Access Compliance Report Public Rights-of-Way (Curb Ramps)

Main Street: LAMBETH_WAY Cross Street: WESTON_PL Location: NE

ADA ID: RPRK220124121643 Ramp Type: Type 4 - Parallel Initial Pass/Fail: Fail Overall Compliance: No Severity Score: 15

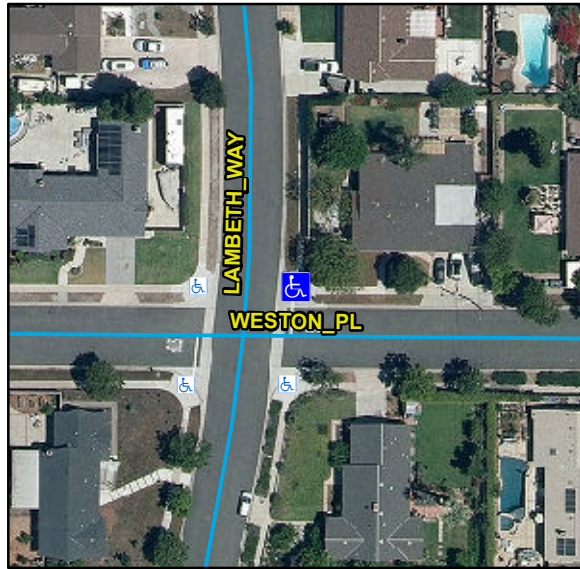
Compliance	Description	Data	Compliance	Description	Data
N/A	Ramp Length LT (in)	89	N/A	Ramp Length RT (in)	86
Yes	Ramp Width LT (in)	122	Yes	Ramp Width RT (in)	122
Yes	Ramp Run Slope LT (%)	2.1	Yes	Ramp Run Slope RT (%)	7.6
No	Ramp Cross Slope LT (%)	5.3	No	Ramp Cross Slope RT (%)	4.6
N/A	Landing Present	N/A	N/A	DWS Provided	N/A
N/A	Landing Length (in)	N/A	N/A	DWS Contrast	N/A
N/A	Landing Width (in)	N/A	N/A	DWS Length (in)	N/A
N/A	Landing Run Slope (%)	N/A	N/A	DWS Full Width	N/A
N/A	Landing Cross Slope (%)	N/A		DWS Offset Type	N/A
N/A	Landing Movement Obstructed?	N/A	N/A	DWS Offset Left (in)	N/A
	Landing Movement Type	N/A	N/A	DWS Offset Right (in)	N/A
N/A	Landing Shared	N/A			
N/A	Clear Space	Yes			
N/A	Clear Space To Crosswalk (in)	N/A			
N/A	Marked Crosswalk 1	No	N/A	Marked Crosswalk 2	No
	Crossing 1 Direction	W		Crossing 2 Direction	S
	Marked Crosswalk 1 Width (in)	N/A		Marked Crosswalk 2 Width (in)	N/A

Remove & Replace Curb Ramp With Two New Directional Ramps or Equivalent.

R304.5.3, STD 1115
